**WHEELING PLAN COMMISSION
THURSDAY, JANUARY 26, 2017 6:30 P.M.**

**AGENDA FOR A REGULAR MEETING OF THE PLAN COMMISSION
to be held in the Board Room of the Village Hall
2 Community Boulevard, Wheeling, Illinois**

REQUEST FOR PLAN COMMISSION ACTION
STAFF PROJECT REVIEW

RE: **Docket Nos. 2016-24A&B and PC 16-18**
(2016-24A) Zoning Variation to Reduce the Parking Setback
(2016-24B) Zoning Variation to Eliminate the Required Screening
(PC 16-18) Site Plan and Appearance Approval of a Parking Lot
300 S. Milwaukee Avenue
Site Plan and Approval for Construction of a Parking Lot

1
L2.1
LANDSCAPE / SITE PLAN
3/32"=1'-0"

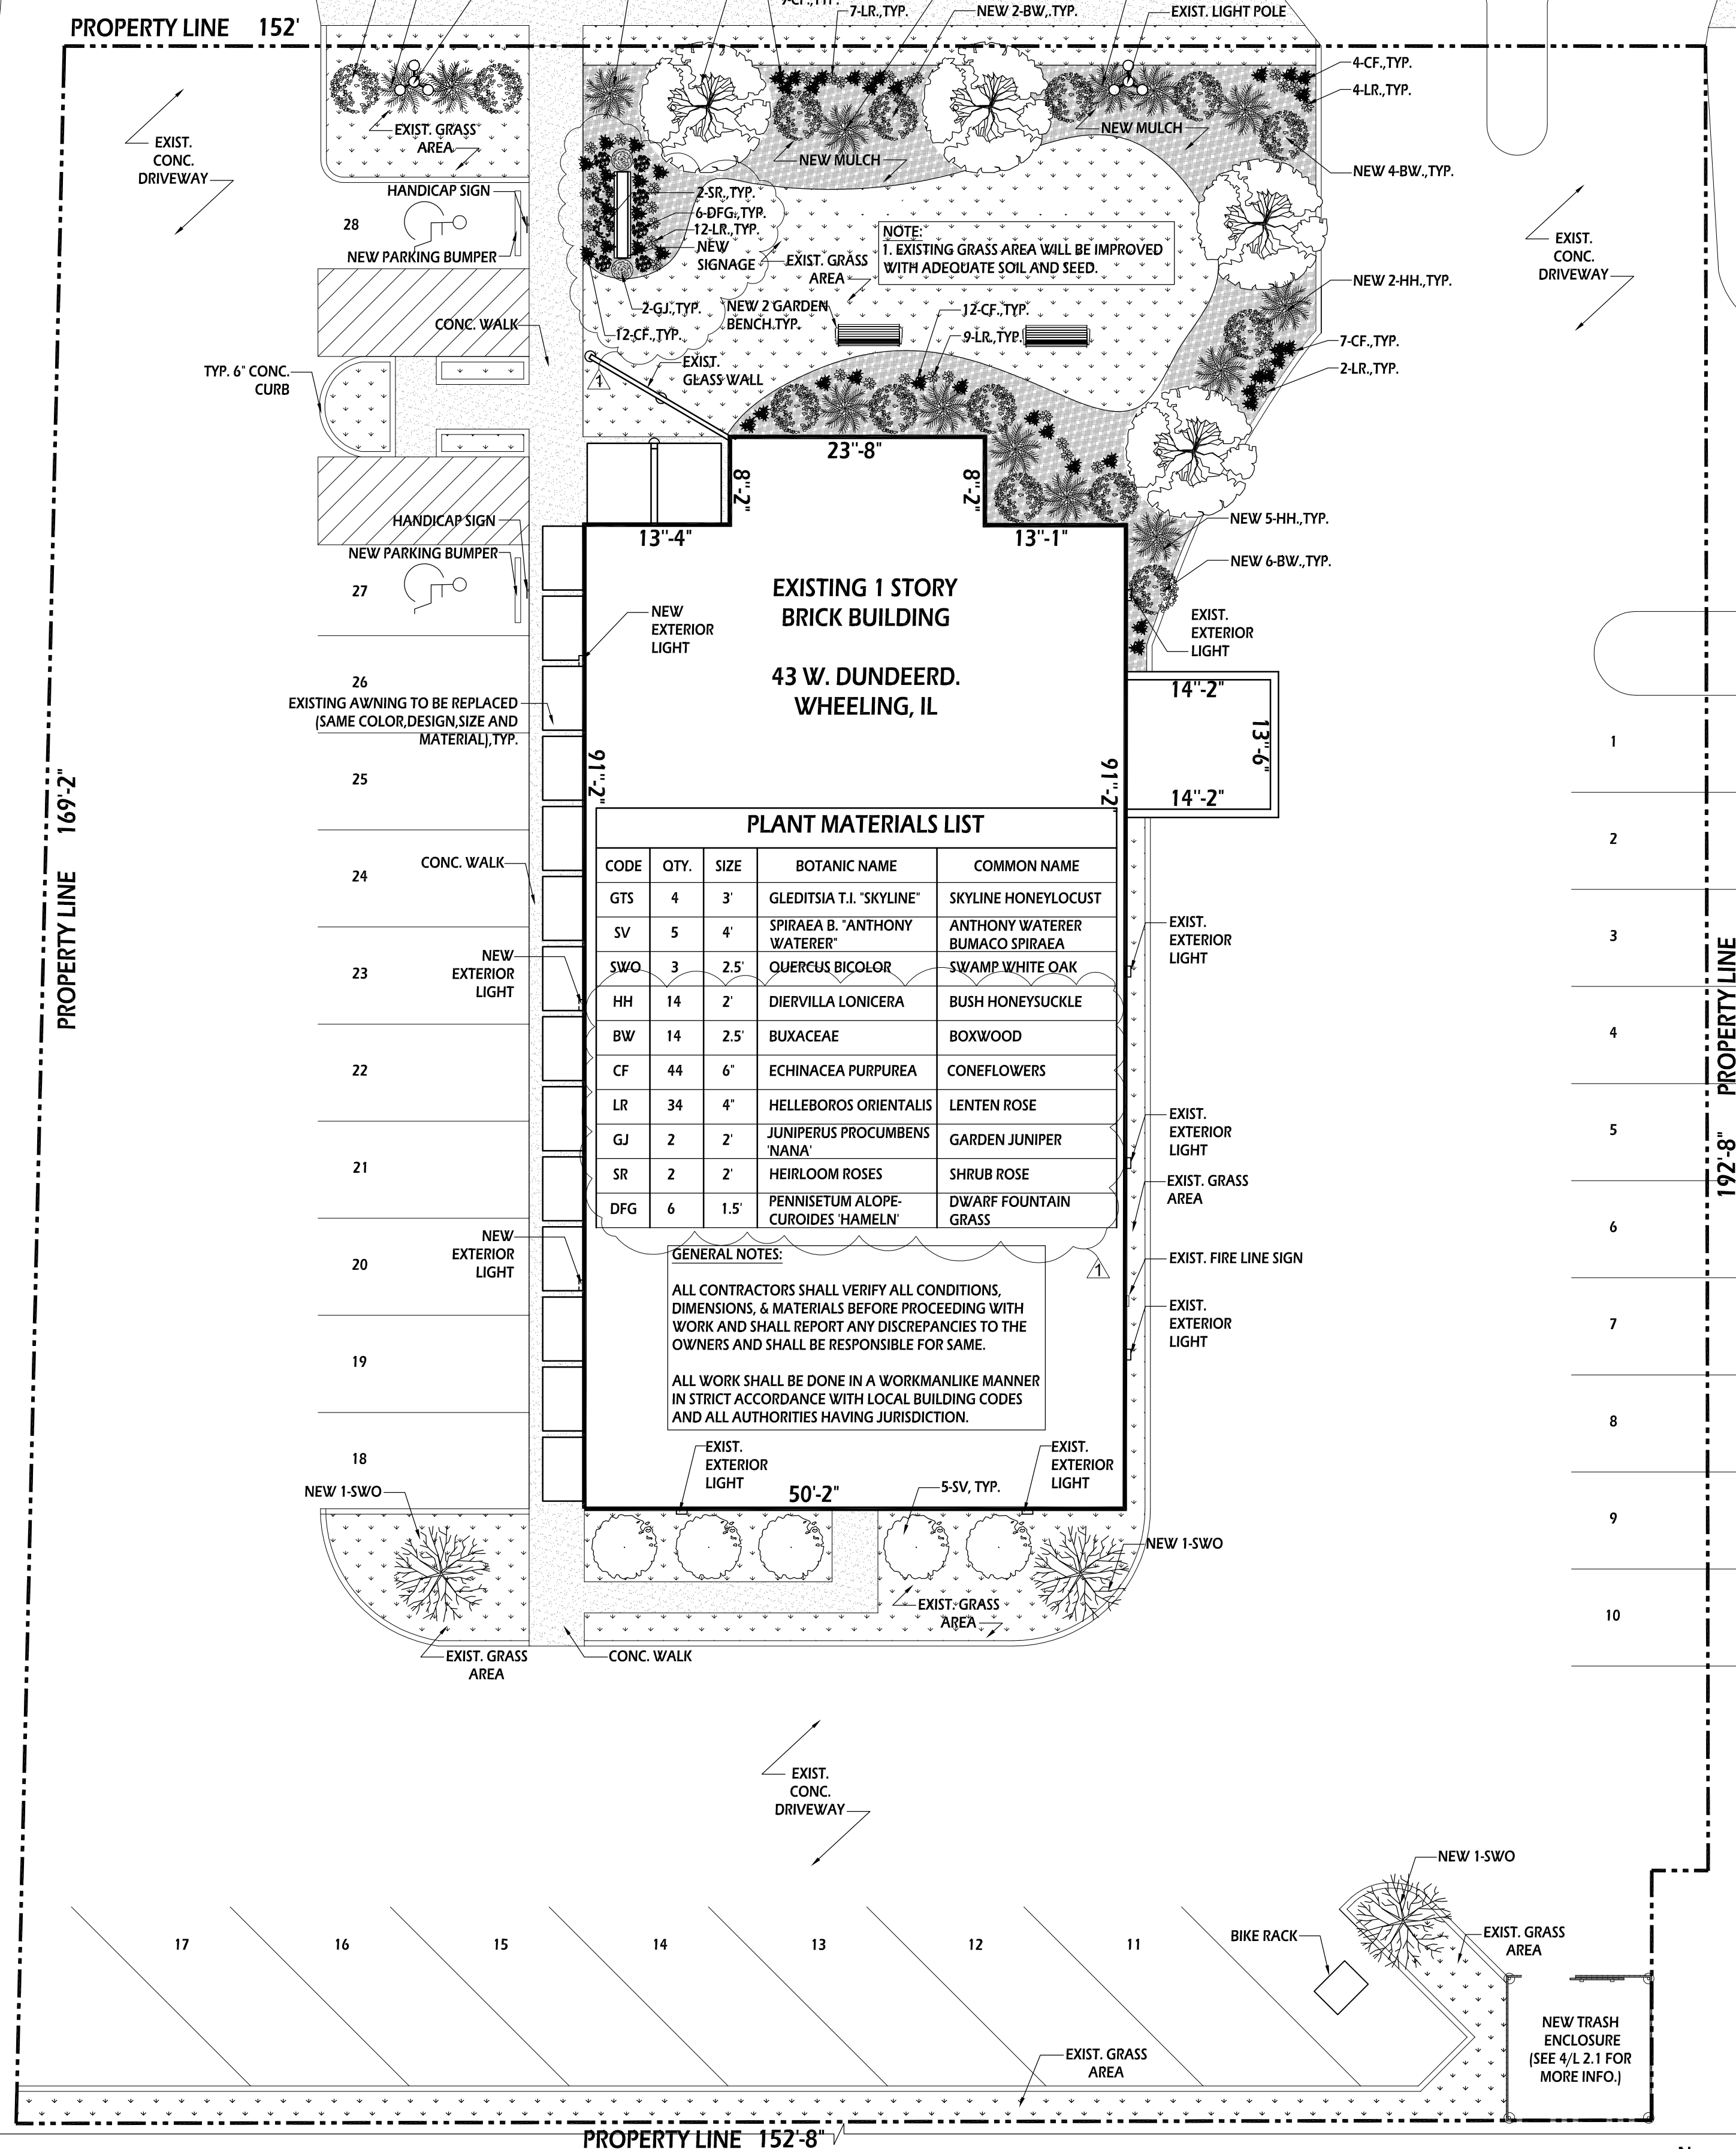
Landscaping: A landscape plan is proposed for the freestanding sign. The proposed landscaped area is approximately 120 sq. ft. The required area is 80 sq. ft. The proposed landscape plan meets the species mix requirements of the Sign Code. It includes evergreens and winter interest (boxwood and garden juniper), flowering perennials (coneflowers, Lenten rose, shrub rose), and ornamental grasses (dwarf fountain grass).

Contract No. PNC 15-9
Siding 1 Windows 1
322 N. Milwaukee Ave.
Minor Site Plan & Appearance Changes
PNC Approved Dec. 3, 2015

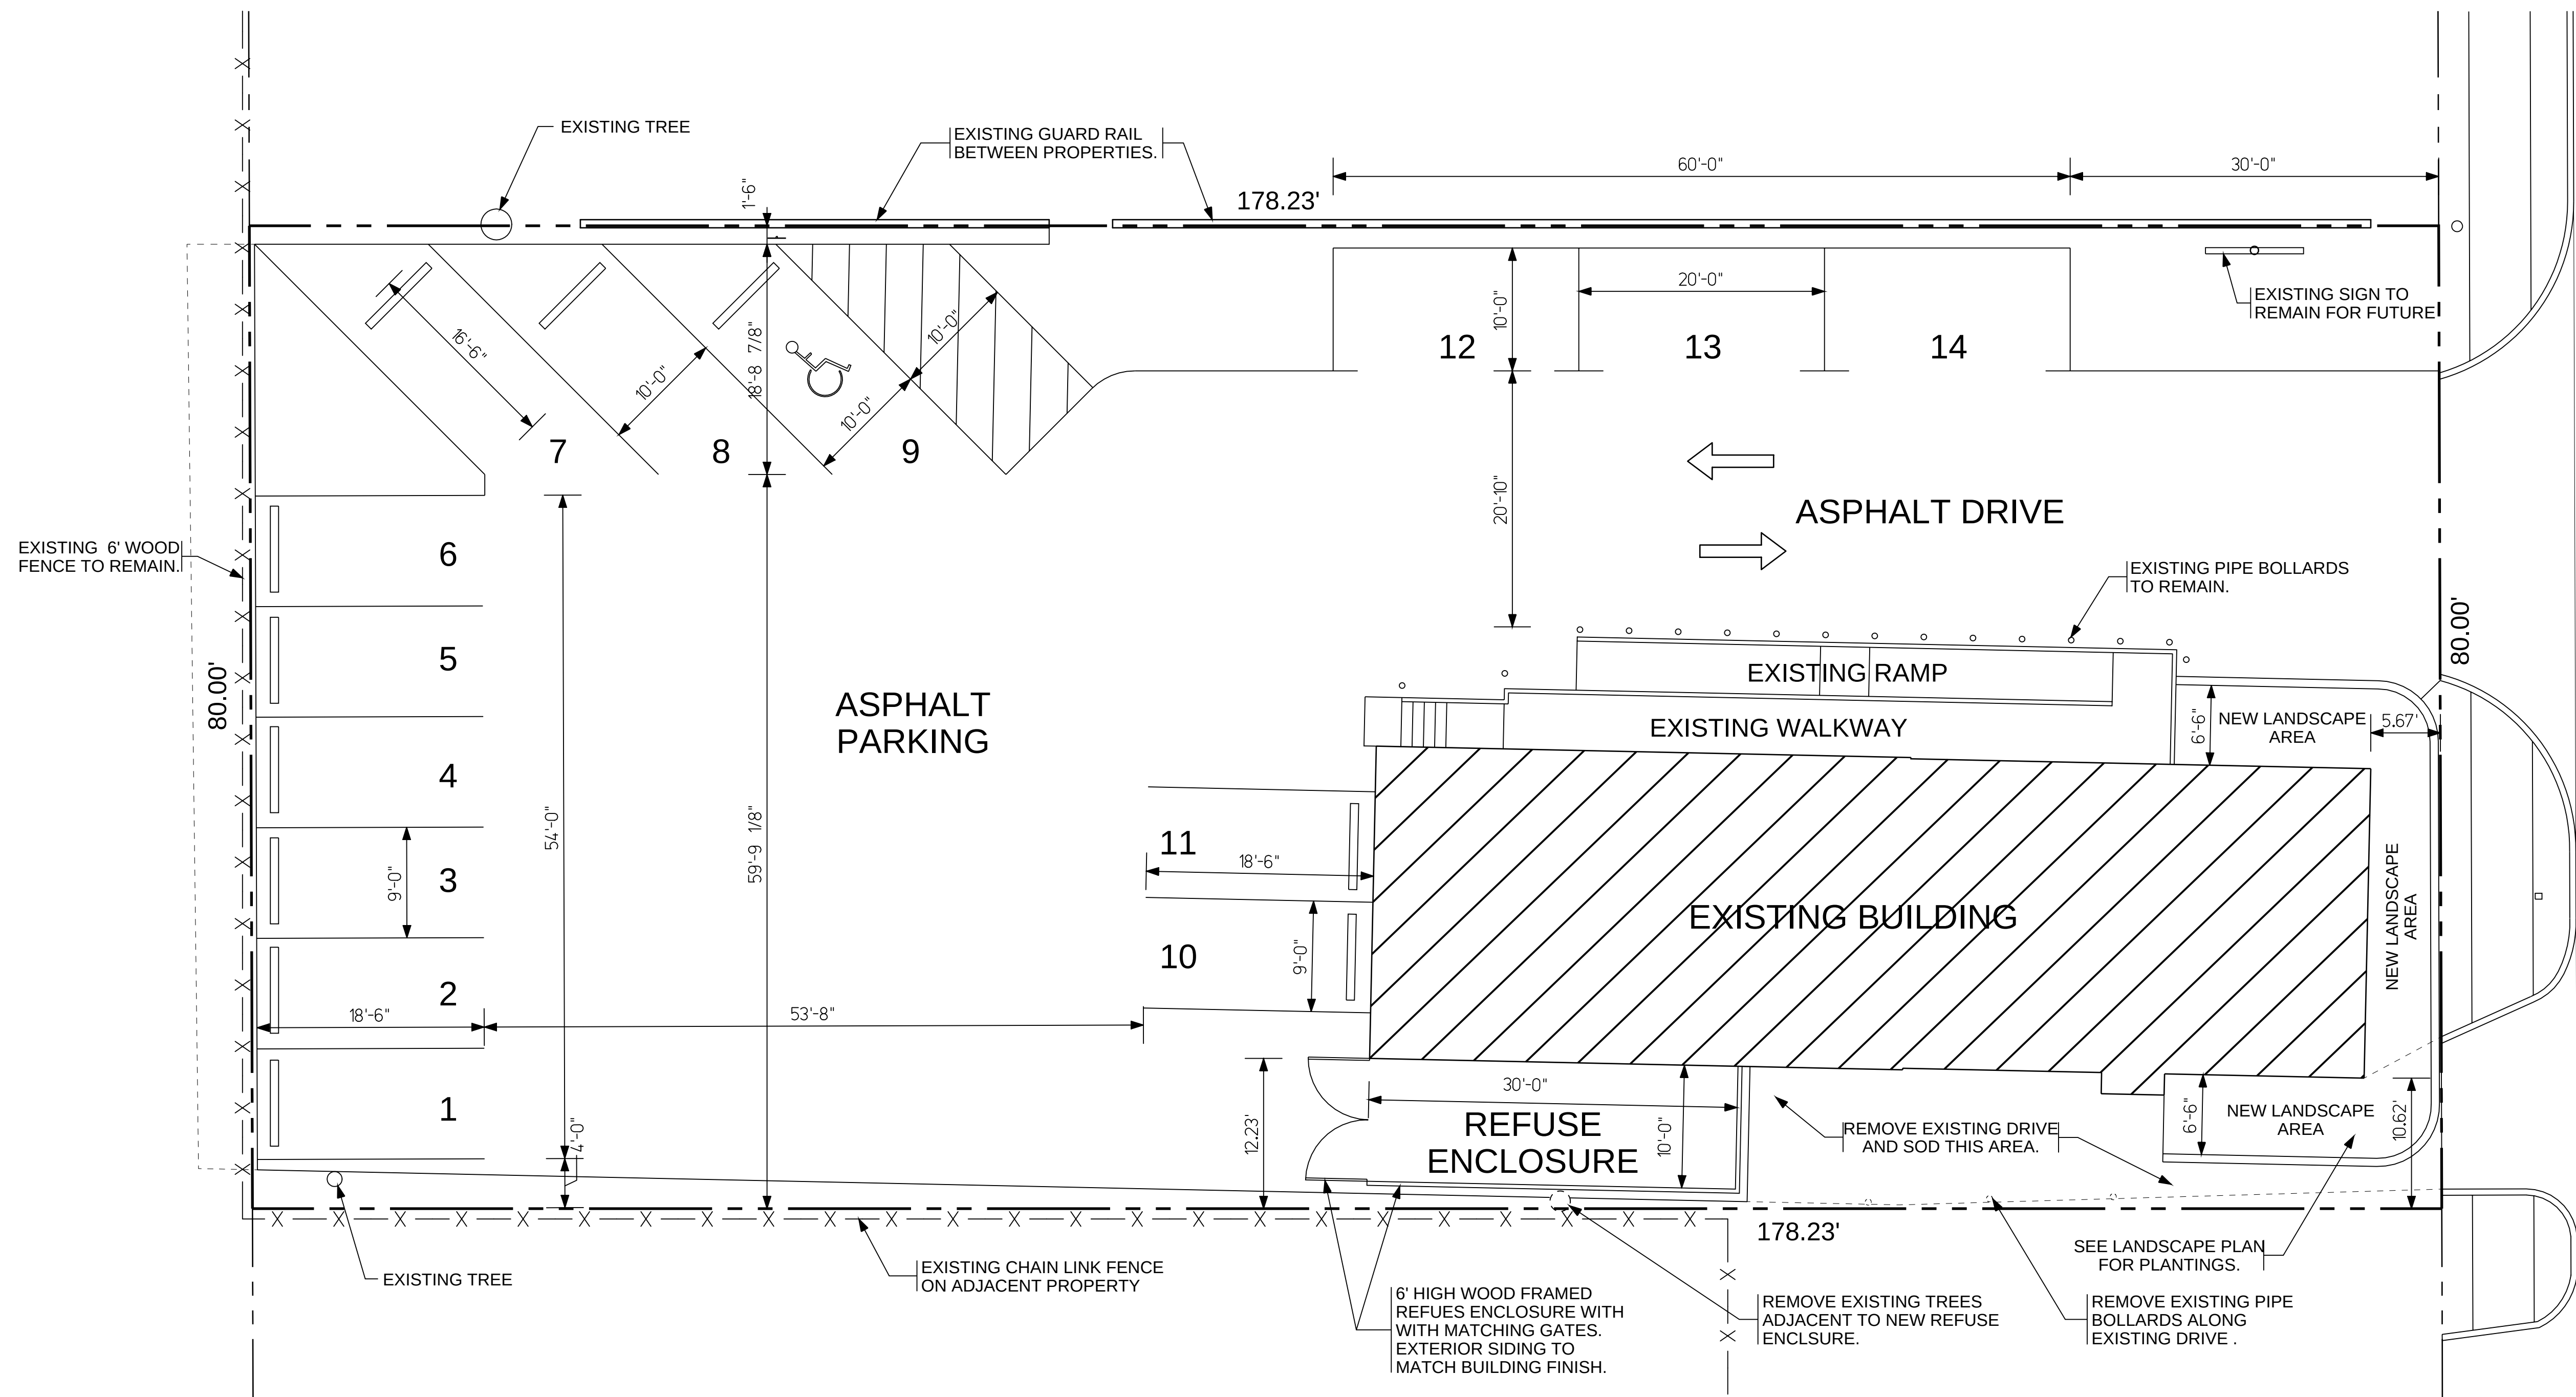
Sign Location: There is an existing single-pole sign near the north property line. This sign has a variation for its setback. The approved site plan for Docket No. PC 15-9 is provided to show the location of the sign.
